# Groundwater Application Review Summary Form

Application # LL-1777

# MEMO

**To:** Kristopher Byrd, Well Construction and Compliance Section Manager  
**From:** Joel Jeffery, Well Construction Program Coordinator  
**Subject:** Review of Limited License Application LL-1777  
**Date:** May 28, 2019

Well Location Map

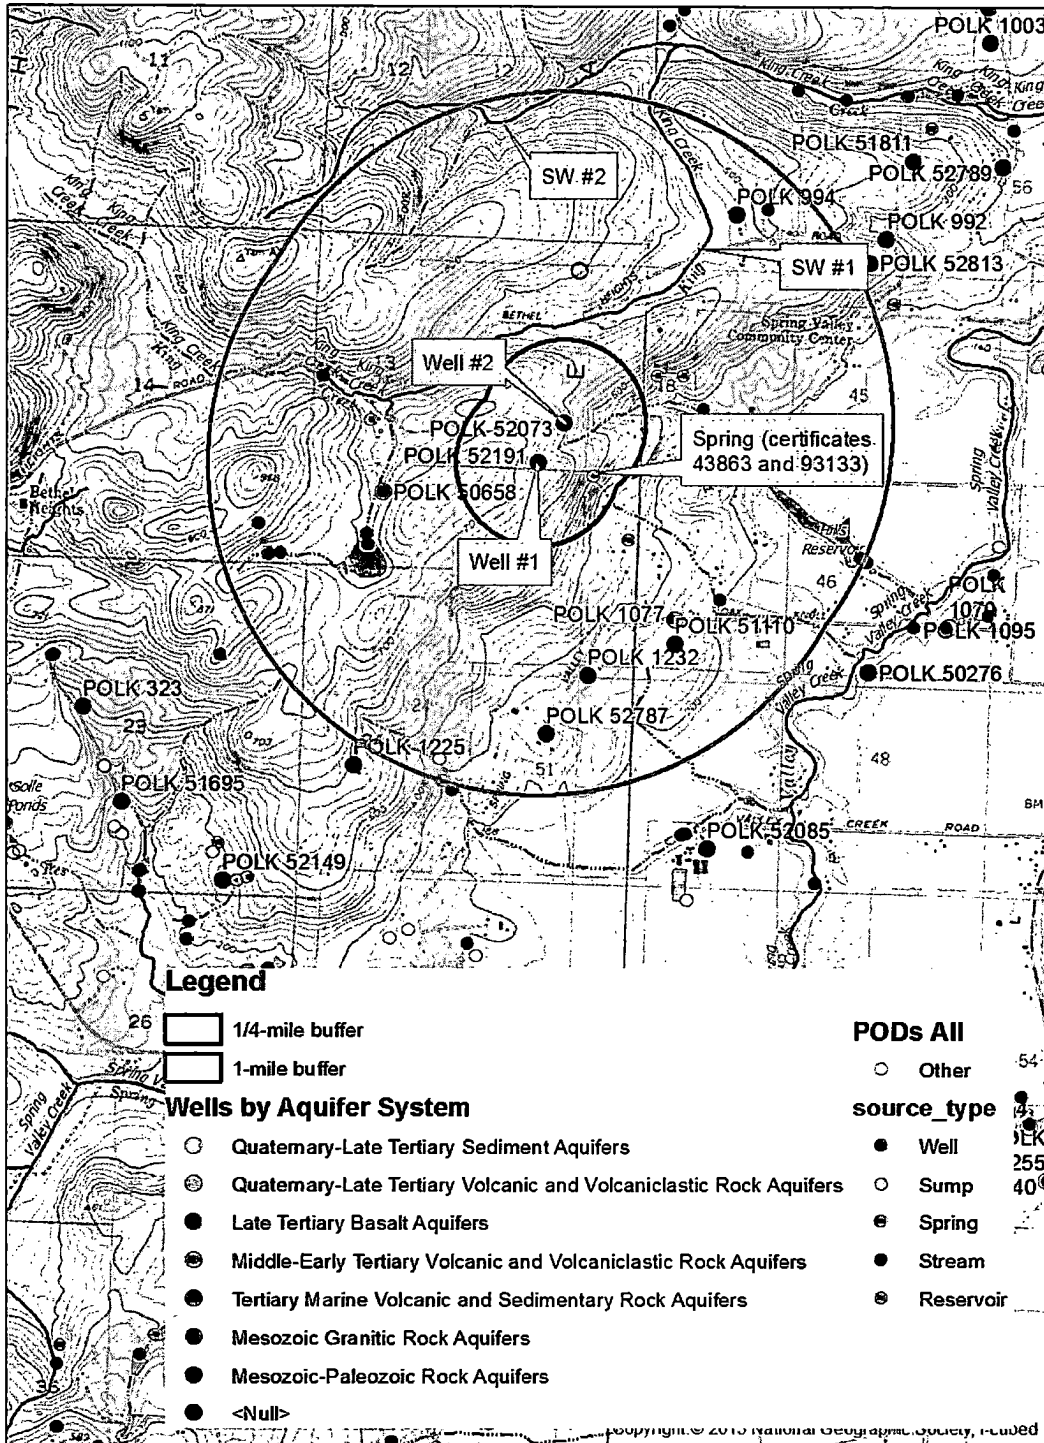
- B3. **Groundwater availability remarks:** The proposed POAs, POLK 52191 and POLK 52703, are located the southeastern foothills of the Eola Hills, which are comprised of Columbia River Basalt Group (CRBG) flows overlying older marine sedimentary rocks. In this area the Miocene CRB overlies Eocene marine sedimentary rocks. Extensive surficial contacts between the CRB and marine sedimentary rocks are mapped near the wells' location, which implies that the CRB pinches out at those locations (Woodward and others, 1998; Conlon and others, 2005; Gannett and others, 1998). However, closer review of area well logs (e.g., POLK 52787, POLK 1232, and POLK 50276) suggests that the areal extent and thickness of the CRB at and near the subject wells are somewhat greater than indicated on regional USGS geologic maps (Conlon and others, 2005). On this basis, it is concluded that the water-bearing "brown weathered rock rock" shown from 161-318 ft bgs on the POLK 52191 well log, as well as the water-bearing "weathered rock brown with hard seams" from 151-220 ft bgs on the POLK 52073 well log, are both accessing aquifers in the CRB and not the underlying marine sedimentary rock units.

There is a permitted spring with multiple associated rights ((Certificates 43863 and 93133) within 900-1,000 ft. of the subject wells and at an elevation consistent with their water levels. Analytic modeling using the Theis (1941) drawdown model with relevant parameters (Conlon and others, 2005) suggests that pumping at the proposed rate for 100 days would likely cause over 10 ft of drawdown at the spring (see figures below). Furthermore, the stream that originates at this spring is mapped as intermittent (USGS, 2018; dashed line on map below), suggesting that any reduction in water pressure in the aquifer would decrease the duration of spring flow each year. Therefore, the proposed use is likely interfere with the spring and cause a senior user not to receive their entitled water. Other permitted spring rights exist within ~2,000 ft of the subject wells (Certificates 30528, 31628, 60891, and 60892) and may also be injured by the proposed use. In case a permit is issued, the conditions noted in B1(d) are required by the Willamette Basin rules for CRB wells and will enable monitoring for use above the capacity of the resource.

- The permit should contain condition #(s) 7i (Willamette CRB conditions); large water-use reporting
  - The permit should be conditioned as indicated in item 2 below.
